Fish Passage Modeling Technical Memo – Stoughton 4th Street Multi-Use Trail Underpass

PREPARED FOR: Wisconsin Department of Natural Resources

RE: Chapter 30 Comments #5, Received 10/10/2023

DATE: February 28, 2024

Figure 5. Depth and velocity graphs for Scenario 1, low flow. 43 cfs = 1/3 of 130 cfs river flow.

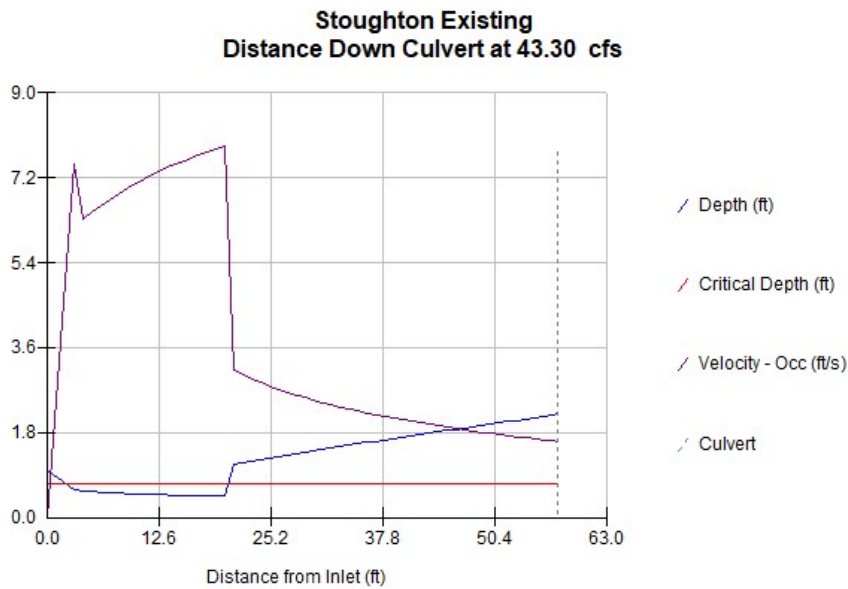
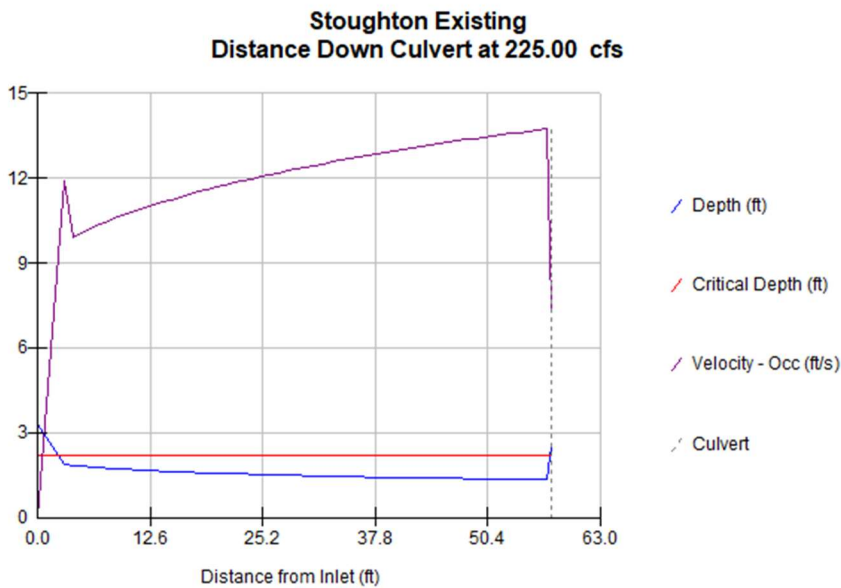
There is concern that the flows within the culverts may be modified to a point that would impact fish movement at certain flows. Please provide modeling of fish crossing capabilities (burst speeds and continuous swimming speeds) for various species, including, but not limited to, muskellunge, white sucker, northern hog sucker, channel catfish, largemouth bass, freshwater drum, shorthead redhorse, walleye, northern pike. The U.S. Forest Service has an Aquatic Organism Passage Program with modeling software that can help to determine whether certain fish species will be able to pass through culverts: Aquatic Organism Passage Program ([usda.gov](https://www.usda.gov)).

Scenario 1 results are shown below. At low flow, a maximum average velocity of 7.86 ft/s occurs 20 feet from the culvert entrance. At high flow, a maximum average velocity of 13.71 ft/s occurs at the culvert exit. The high velocity is attributed to a hydraulic jump that occurs inside the culvert at all modeled flows. Upstream of the hydraulic jump, flow velocities create a barrier to fish passage. With increasing flows, the hydraulic jump and associated velocity barrier moves downstream.

Based on the modeling and analysis described in this report, the existing 4th St box culverts present a velocity fish passage barrier to all fish species and flows analyzed. The velocities modeled for existing low flow conditions (130cfs) present velocities that are higher than the fastest continuous swim speed and fastest burst speed of any of the fish species, and velocities increase as flows increase. The proposed project will increase velocities as compared to existing due to more flow per culvert at river discharges under 700cfs, but since the existing culverts already present a velocity fish passage barrier to all fish species, the project won't functionally change fish passage. The existing culverts are a barrier to all fish species analyzed and will continue to be post-project.
